DEVIATION TO APPROVED PLAN No. 196-04-15:

DEVIATIONS TO APPROVED PLAN No.196 04 15 PORTION 91 OF ERF 3137 DURBAN NORTH 57 MACKEURTAN AVENUE, DURBAN NORTH FOR MR & MRS NAUDE

SITE PLAN • FLOOR LAYOUTS

drawn by: rs • scale: as-shown • revision: . • drawing no: 15 068-LA1-001

SITE PLAN SCALE 1:250

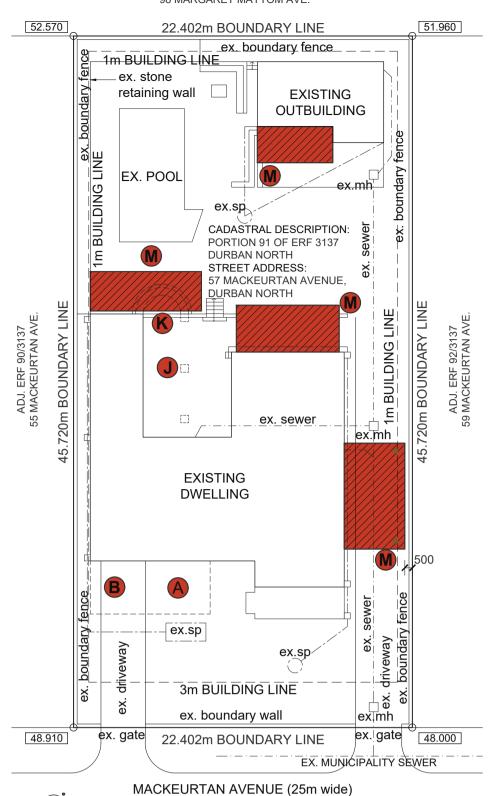
EN-SUITE OMITTED. PROPOSED EXTENSION REDUCE.

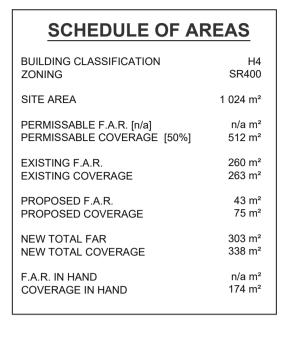
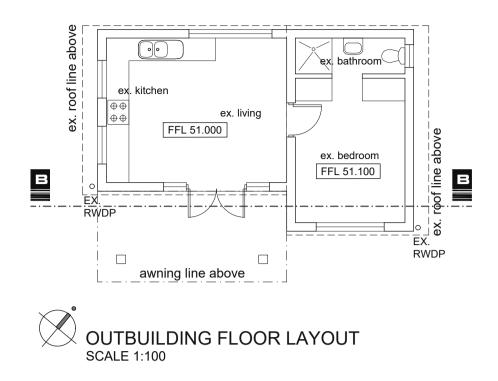
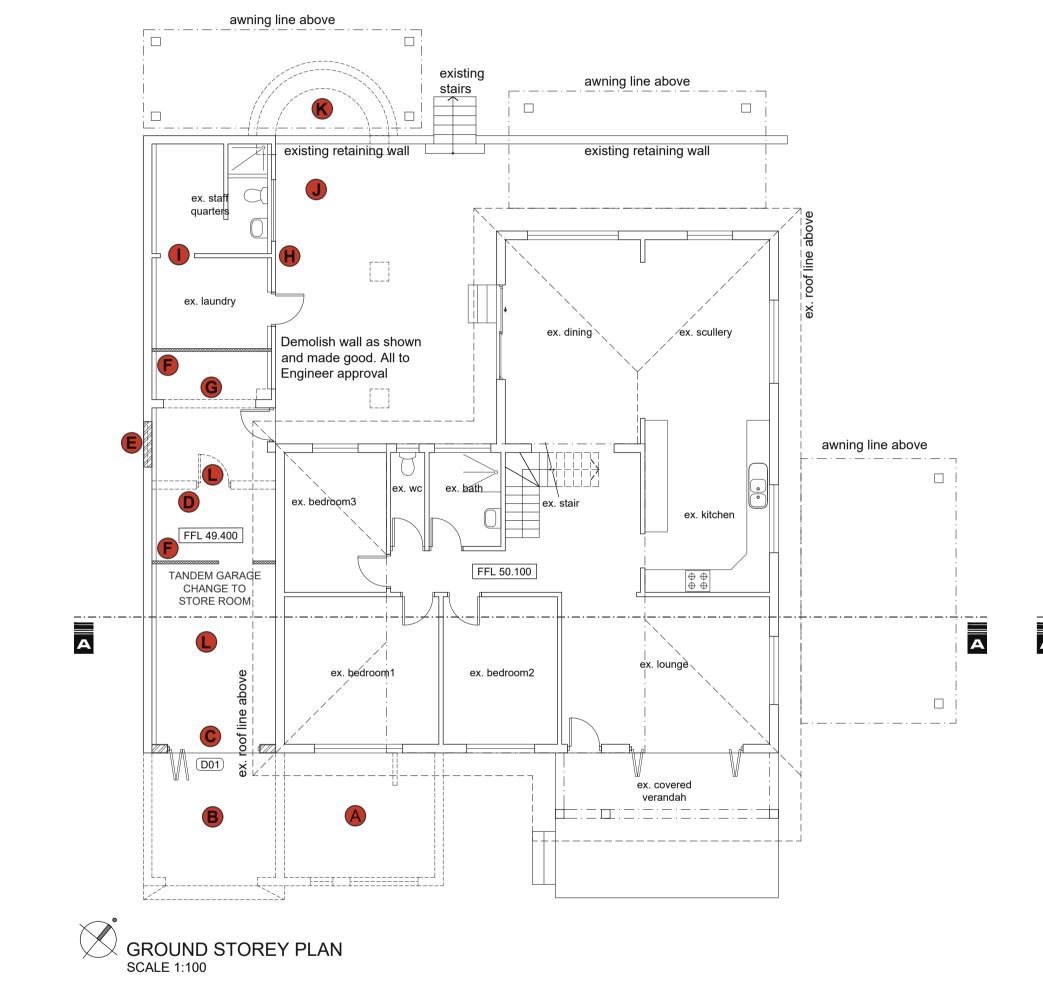
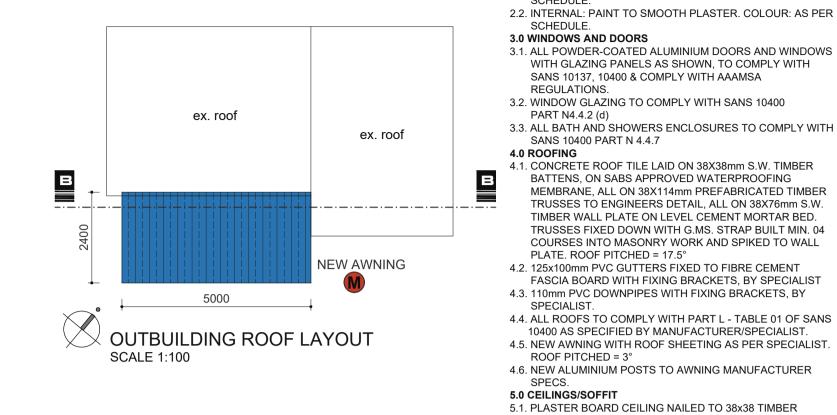
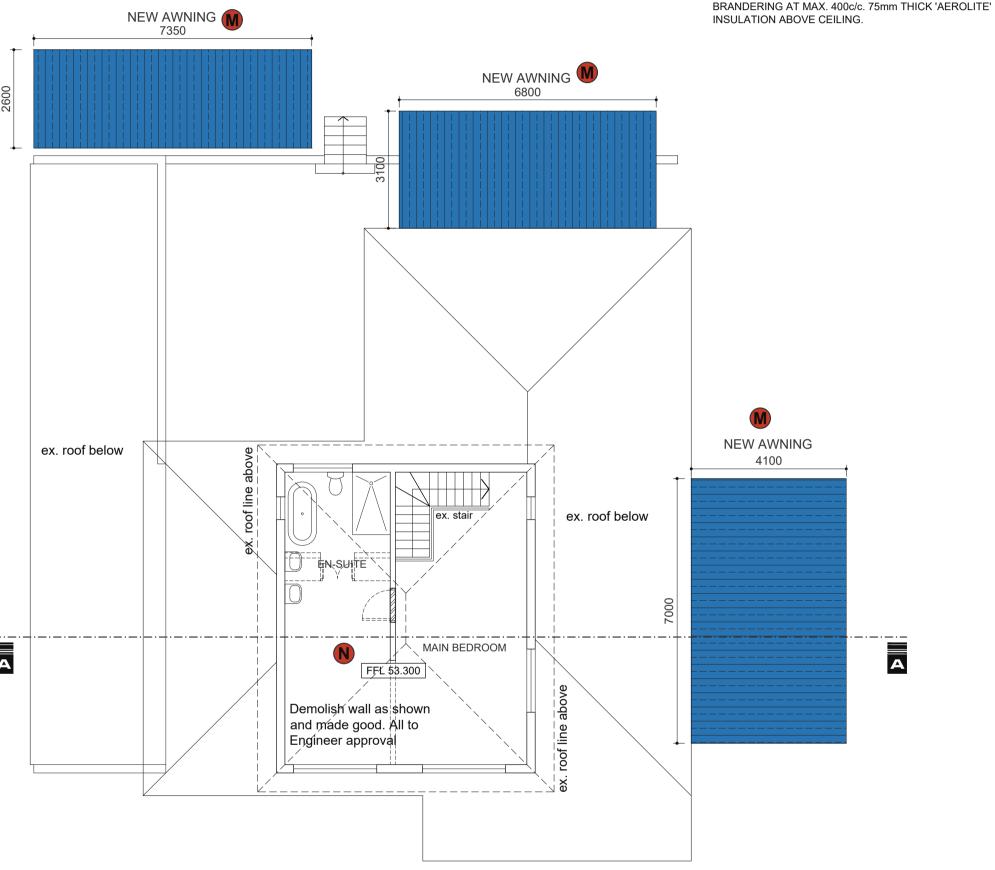
STACKING DOOR REPLACED GARAGE DOOR.

INTERNAL WALL AND DOOR OMITTED.

BRICKED UP WINDOW.

NEW STANDARD DRYWALL.

INTERNAL WALL OMITTED.

WALL, DOOR & WINDOW REINSTATED.

STAFF QUARTERS AND LAUNDRY REINSTATED.

ENTERTAINMENT AREA OMITTED.

FEATURED SEATING OMITTED.

TANDEM GARAGE CHANGED TO STORE ROOMS.

NEW AWNING.

2nd STOREY CONVERTED TO MAIN BEDROOM & EN-SUITE.

ROOF PITCH CHANGED.
